CITY OF TONTITOWN PLANNING OFFICE

Meeting: **March 26, 2019**
Project: **Morsani Acres**
Planner: Courtney McNair

- i. **Planned Unit Development (PUD) REQUEST**
- ii. **PRELIMINARY SUBDIVISION PLAT REQUEST**
- iii. **WAIVER REQUEST**

PRELIMINARY LARGE SCALE DEVELOPMENT PLAN APPROVAL REQUEST

UTILITY PLAN

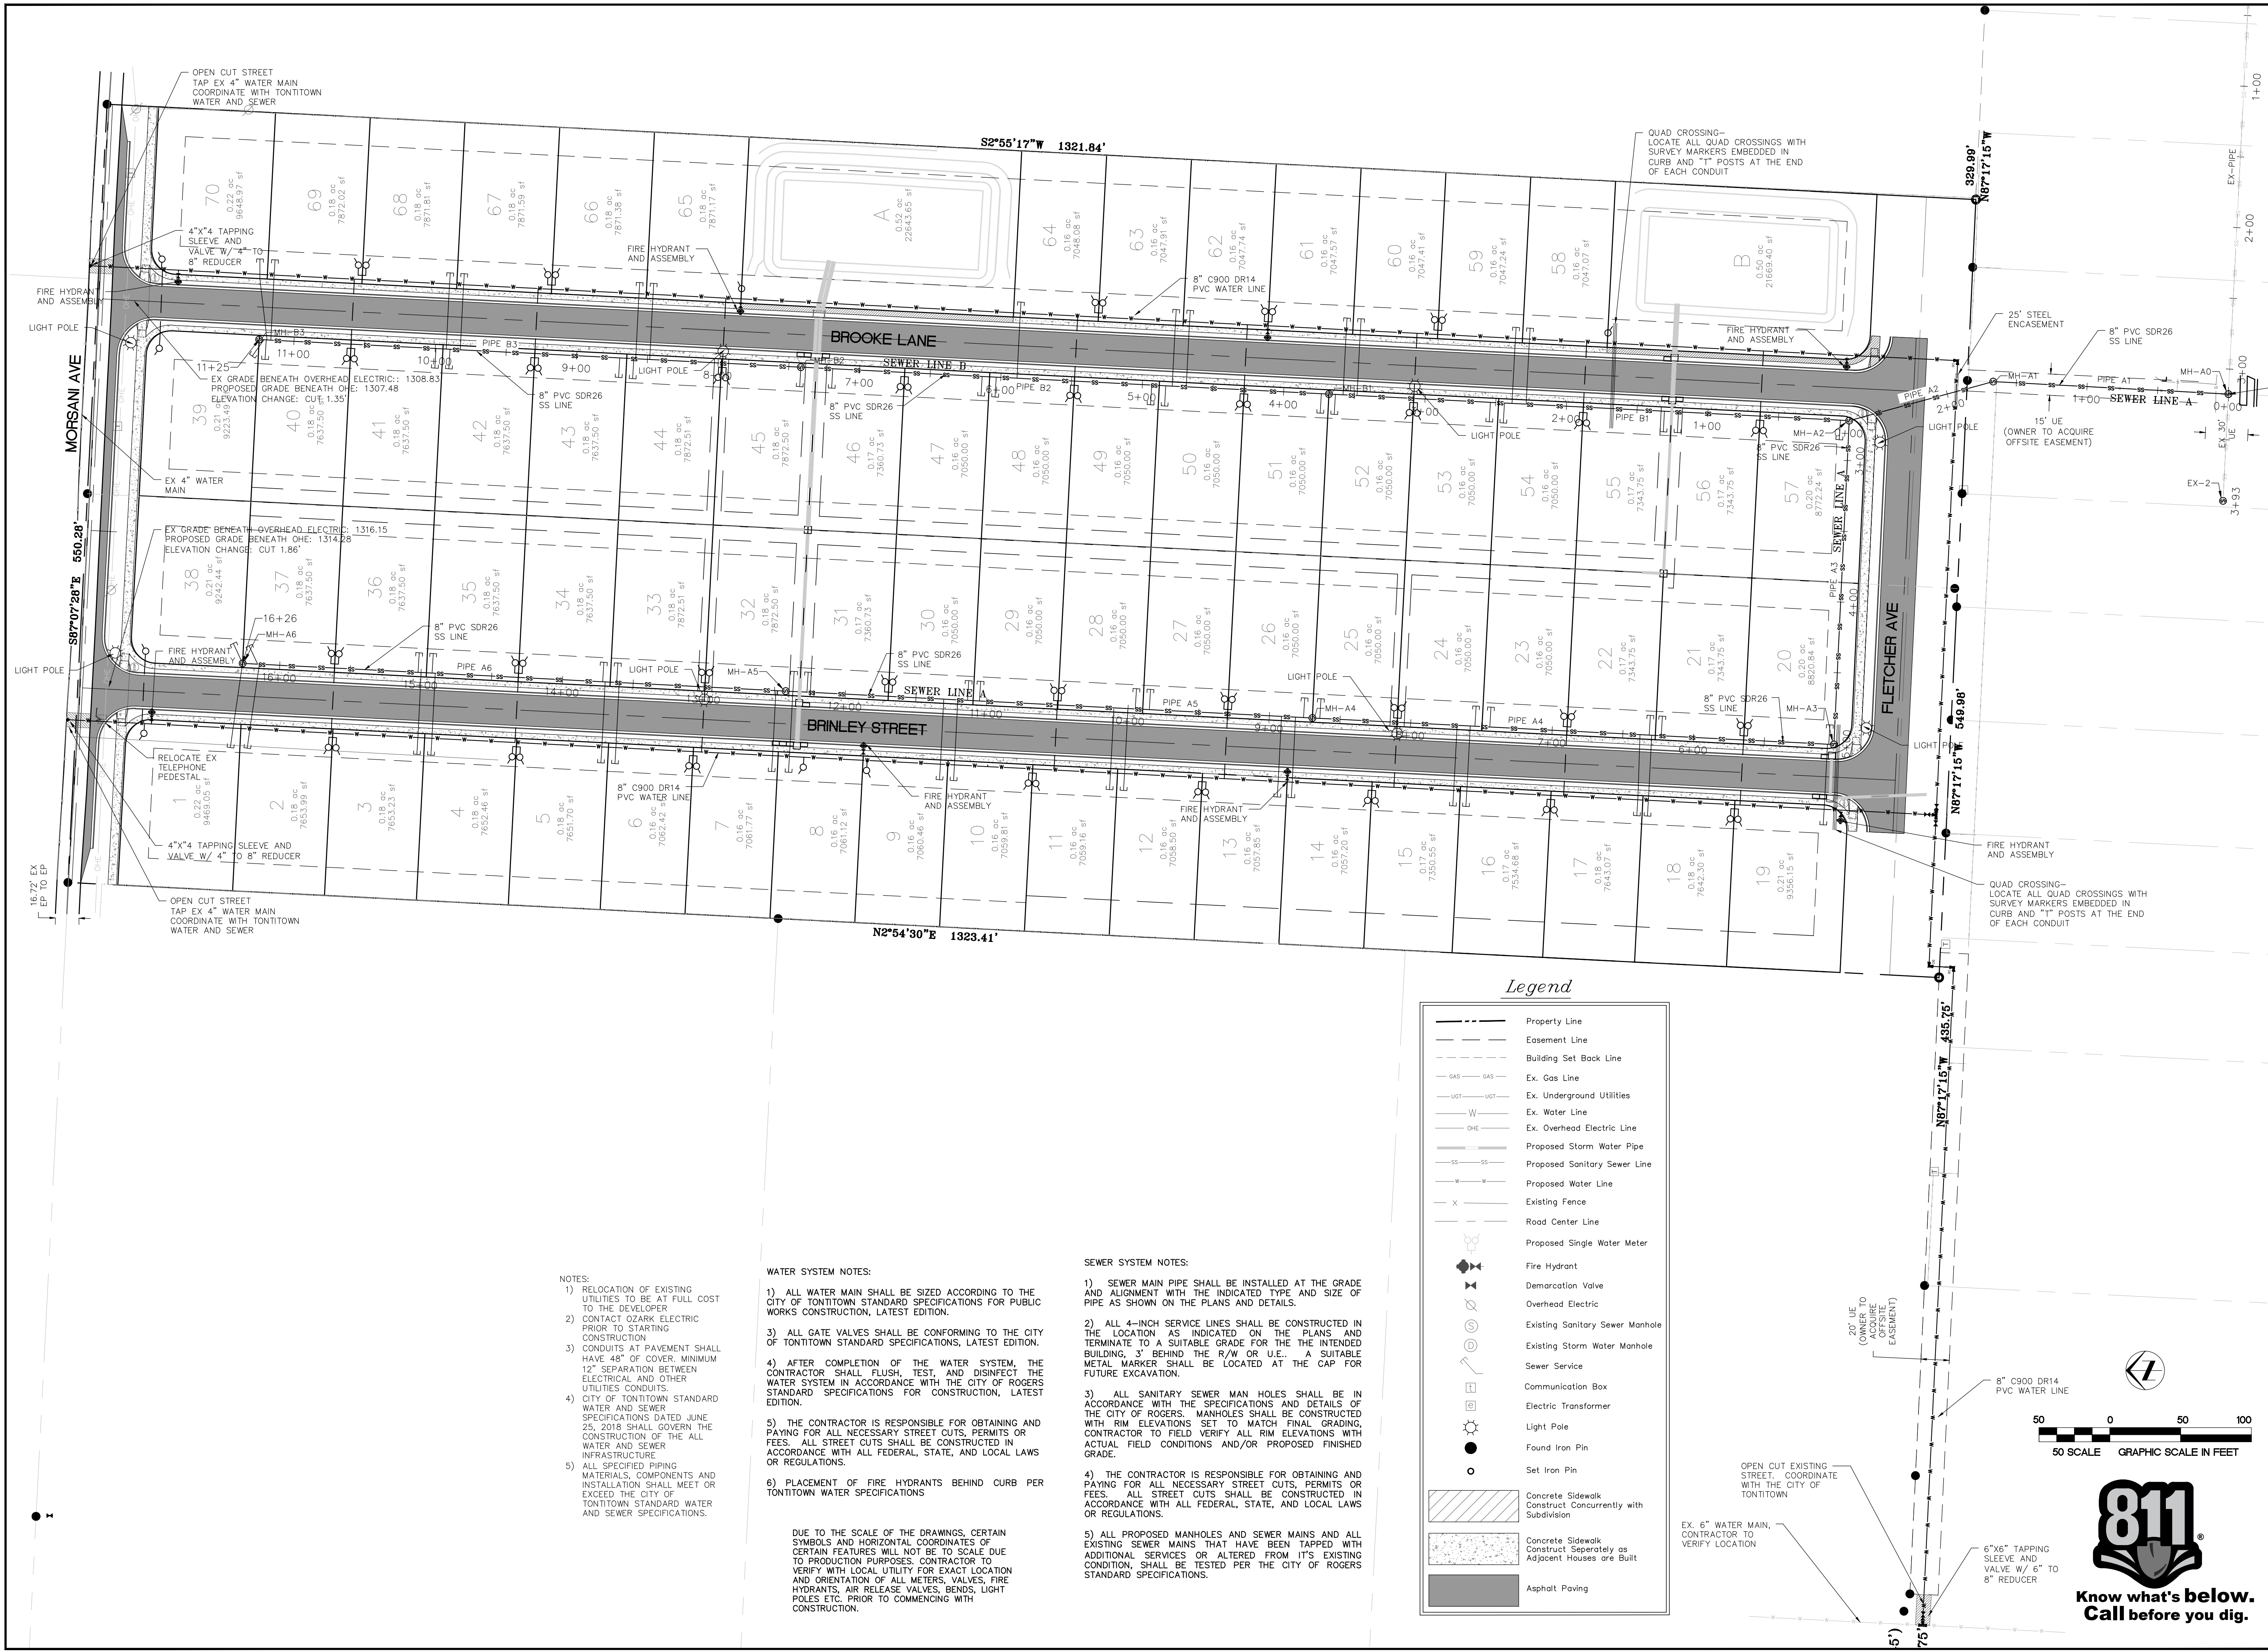
I have attached an email regarding water pressure from the applicant’s engineer. They are planning to loop the water line within this development. Looped lines are generally a better situation for water systems. Additionally, he has addressed the possibility of upgrading waterlines if necessary, to meet required fire flow.

Water: Tontitown Water, the applicant plans to tap into the existing 6-inch line on Bausinger Road to service this property, and then loop to the existing 4-inch line on Morsani Road. Interior water system is proposed to be 8-inch line. All offsite easements are the applicant's responsibility.

There was a concern voiced about the Fire Code access for this development. The Fire Marshal has reviewed the plans and consulted with other local fire marshals for their opinions as well. As the “authority having jurisdiction”, he can make professional assessment of developments within his jurisdiction, and has no concerns regarding this proposal. He did require additional hydrants, and those are shown on the plans.
